STAFF REPORT: DECEMBER 13, 2023, REGULAR MEETING

APPLICATION NUMBER: HDC2023-00138

ADDRESS: 4086 STURTEVANT

SCOPE: INSTALL VINYL WINDOWS AT REAR PORCH

Image from Wallside website, with bracket added by staff to indicate added thickness.

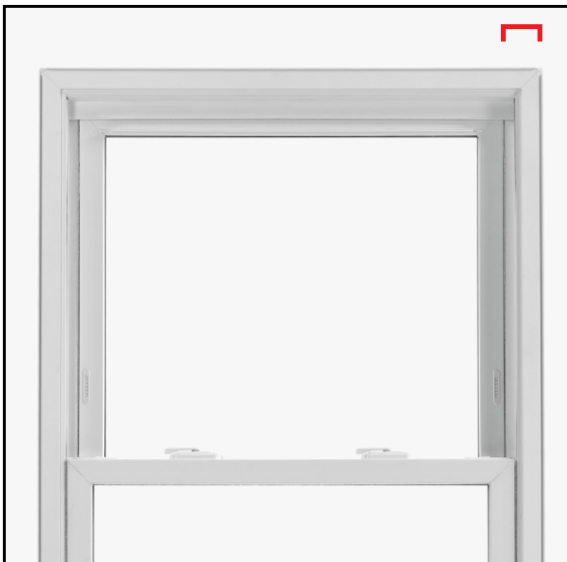
- The proposed work, when taken together, would also noticeably alter the dimensions and character of the window openings, also contrary to Standard #2. The use of new framing and coil stock would result in thicker mullions than the approximately 2” elements visible on the porch presently. In the existing configuration, each existing screen panel sits within a single, thin, wood frame. Replacement windows, however, employ thicker sashes; further, the sashes are set within an outside frame that also adds thickness. The thicker mullions, frames and sashes would decrease the sense of openness that is an important feature of the porch.

- The proposed work introduces vinyl, a material that is incompatible with the character of the building. (The use of wood or aluminum windows would likely be appropriate.)
- The proposed work removes original mullions, a feature that contributes to the historic character of the building.
- The proposed work reduces the size of the openings, diminishing the open character that is a defining feature of a sun porch. (Work that does not alter the existing openings, such as the use of removeable storm windows or permanent windows that are able to fit into the existing openings without alteration, would likely be appropriate.)
